Technical Information

33.97

Model 034, 036, 036 QS Chainsaws - Series 1125

2. Throttle trigger (036 QS only)

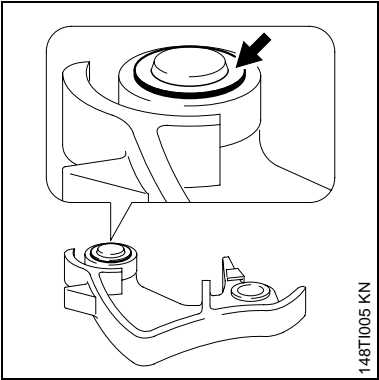
A modified version of throttle trigger 1125 180 1501 is now available. Its function has been further enhanced by fitting a washer 0000 958 0407 to hold the roller in position (see arrow).

The new version of the throttle trigger should always be installed in the case of a repair.
